Enclosure 2

2CAN032001

**Response to Request for Additional Information Related to Proposed Increase in
Control Element Assembly Drop Times
(NON-PROPRIETARY)**

By letter dated December 18, 2019 (Reference 1), Entergy Operations, Inc. (Entergy), requested NRC approval of a proposed change to the Arkansas Nuclear One, Unit 2 (ANO-2) Technical Specifications (TSs) that would increase the existing individual and average Control Element Assembly (CEA) drop times established in TS 3.1.3.4, "CEA Drop Time," by 0.2 seconds.

Figure 1
Reactivity versus CEA Insertion Time
(SAR Figure 15.1.0-1D)

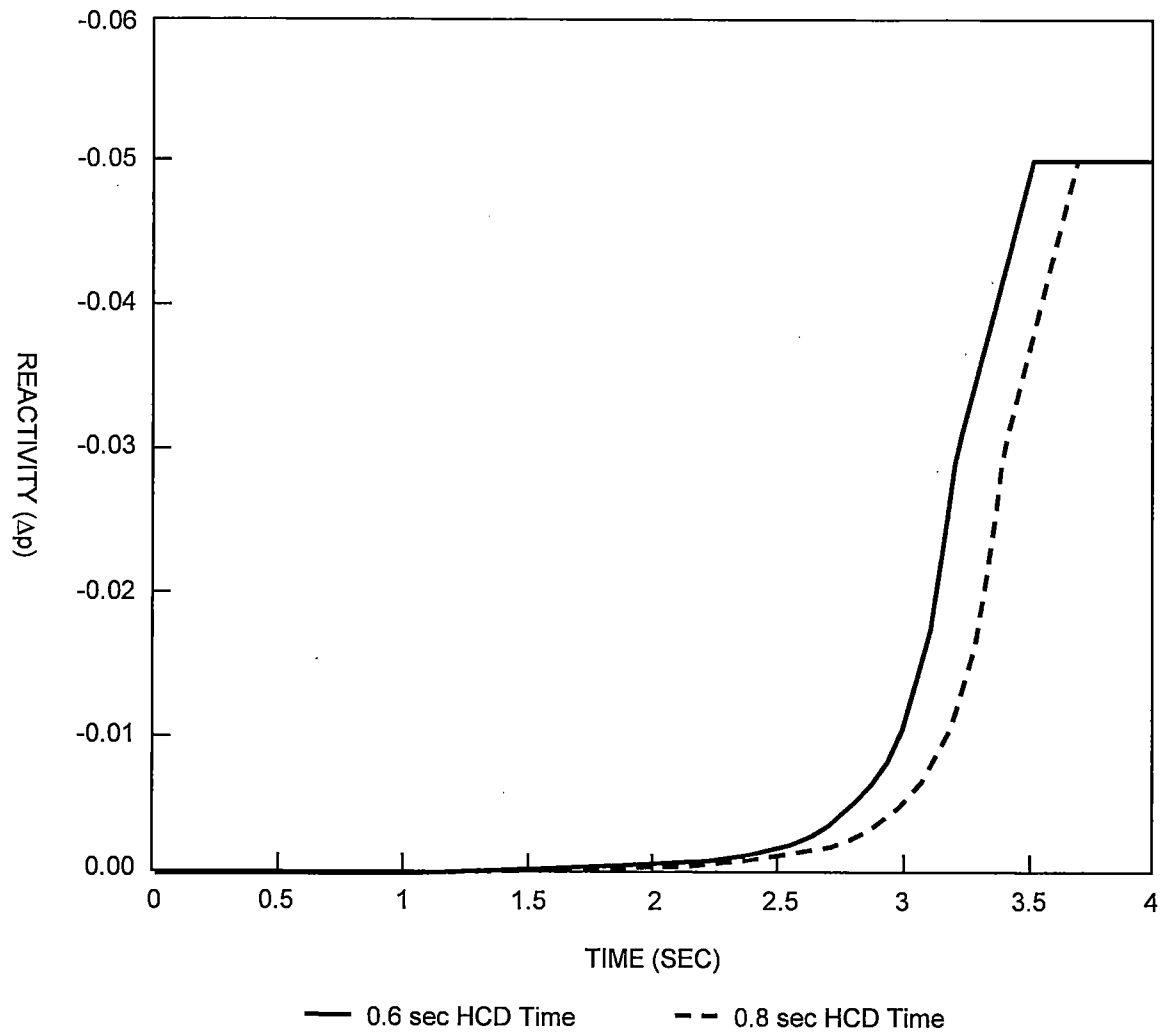
ANO-2 SAR Section 15.1.0.2.3, Shutdown CEA Reactivity, indicates that the CEA insertion reactivity curves in SAR Figure 15.1.1.0-1D (representing CEA reactivity vs. insertion time) and Figure 15.1.1.0-1E (representing CEA insertion position vs. insertion time) were used in the transients and accidents analyses applicable to Cycle 13 and subsequent cycles. The curves were developed based on the assumption that the arithmetic average drop time to 90% inserted was 3.2 seconds, of which 0.6 seconds is attributed to holding coil delay time.

- (a) Discuss whether the same CEA insertion curves in SAR Figure 15.1.1.0-1D and Figure 15.1.1.0-1E were used in the reanalysis or not.
- (b) If the same curves were used, address the acceptability of their use considering that the curves were based on the arithmetic average drop time to 90% inserted of 3.2 seconds vs. 3.4 seconds for the application to the reanalysis.
- (c) If different curves were used, provide the curves and discuss their derivation.
- (d) Clarify how the CEA insertion curves used in the reanalysis would be bounding throughout the upcoming and subsequent operating cycles.

Please note that the actual SAR figure numbers associated with this RAI are Figures 15.1.0-1D and 15.1.0-1E. Figures 1 and 2 provide Reactivity Insertion versus CEA Insertion time (Figure 15.1.0-1D) and CEA Insertion versus Time (Figure 15.1.0-1E) curves, respectively, for the current SAR figures based on 0.6 second holding coil delay (HCD) time, along with revised curves for the 0.8 second HCD time.

- (a) The SAR Figure 15.1.0-1D and Figure 15.1.0-1E CEA insertion curves were used in the reanalysis, unchanged except that the time of the upper gripper coil (UGC) release of the CEA was delayed by 0.2 seconds. This was intended to be captured in the original license amendment request (Reference 1) which states: "This change impacts the reactivity versus time data that is used in the accident analyses. The evaluation of impacts on affected accident analyses applies the additional drop time to the time at which the UGC releases the CEA. The reactivity insertion timing after the UGC releases the CEA is unaffected." This is also reflected in Figure 1 and Figure 2 below as the dashed line.

- (b) With respect to the use of the current SAR figures noted above, should the actual motion of the CEAs be slower than that indicated in SAR Figures 15.1.0-1D and 15.1.0-1E, but the UGC release of the CEA be sooner than the 0.2 second delay from that indicated in the modified CEA insertion curves (Figures 1 and 2 below), then the insertion of negative reactivity would be faster (reducing reactor power more quickly) than that modeled in the analysis. Therefore, the use of the CEA insertion curves in SAR Figures 15.1.0-1D and 15.1.0-1E is conservative provided the results of the CEA drop time testing meets the revised TS acceptance criteria in the same manner as it is with the current TS acceptance criteria.
